STAFF REPORT
COMMUNITY DEVELOPMENT DEPARTMENT

HEARING DATE: February 14, 2023

FROM: Sonya Allen, Associate Planner
208-884-5533

SUBJECT: H-2022-0027
Sagarra – PUD, PP
(aka Linder Village)

F. Parking Diagram – REVISED

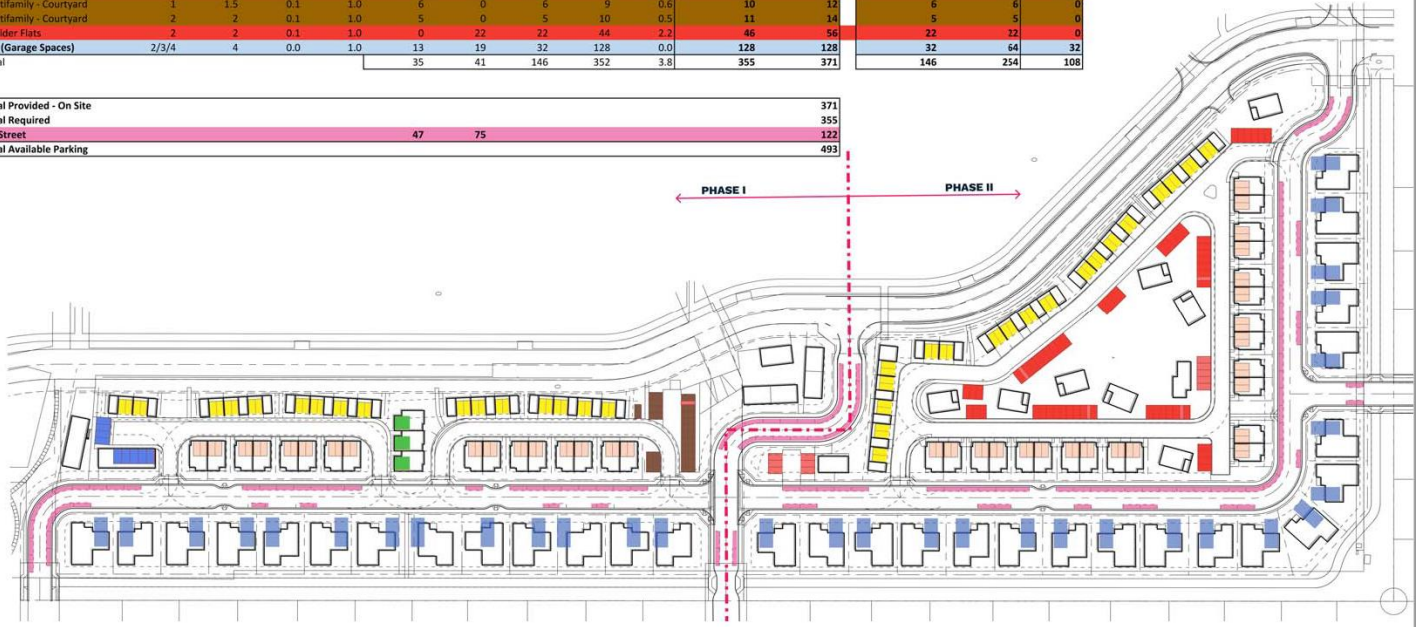
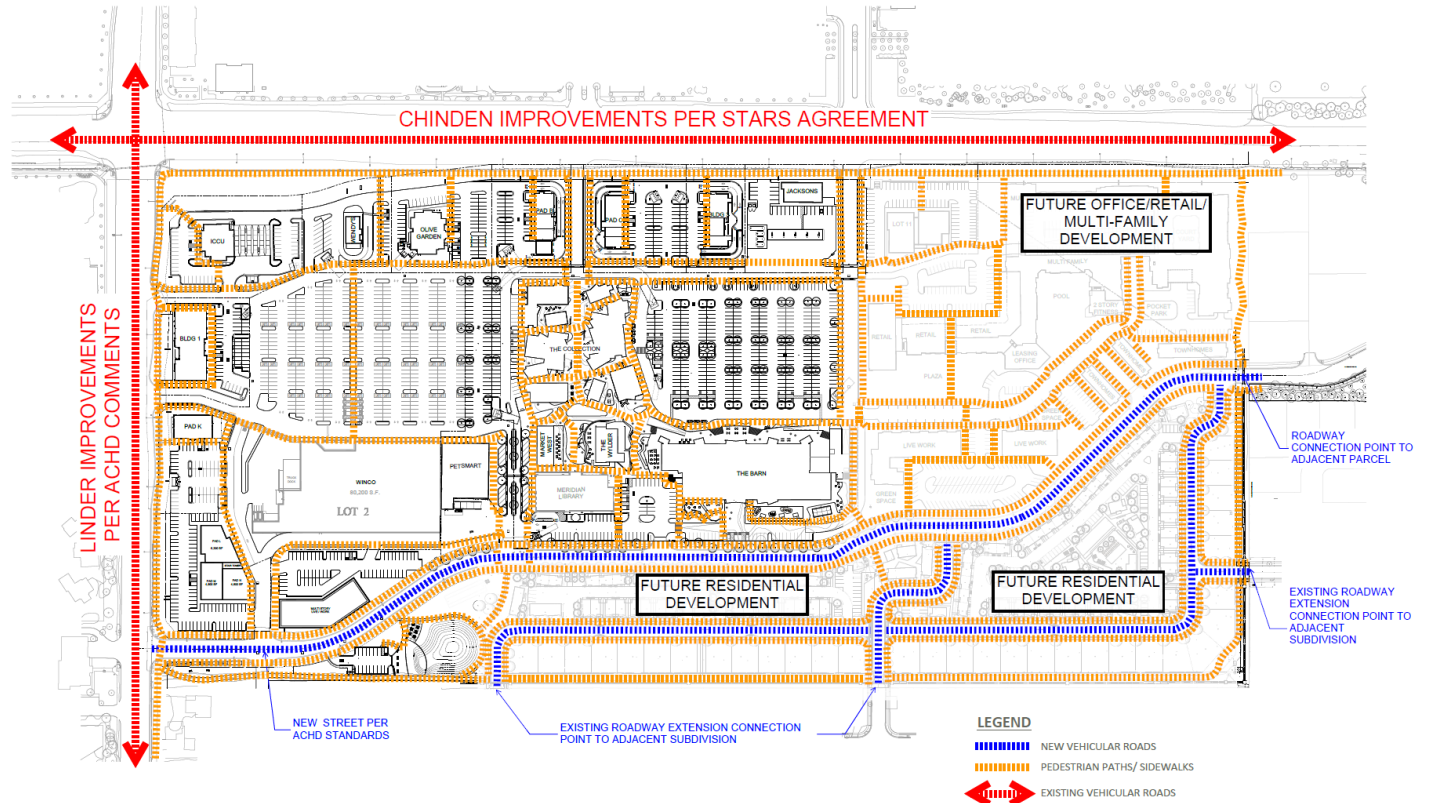
Staff is unable to determine compliance with the minimum standards until a revised parking exhibit is submitted. The proposed off-street parking complies with and exceeds the minimum standards by 16 spaces; an additional 122 on-street parking spaces are also available (see Section VII.F).

- ~~Submit a revised off-street parking exhibit that demonstrates compliance with the minimum standards listed in UDC [Table 11-3C-6](#). See updated parking calculations in Section VII.F. The proposed parking complies with and exceeds the minimum standards by 16 spaces; an additional 122 on-street parking spaces are also available.~~
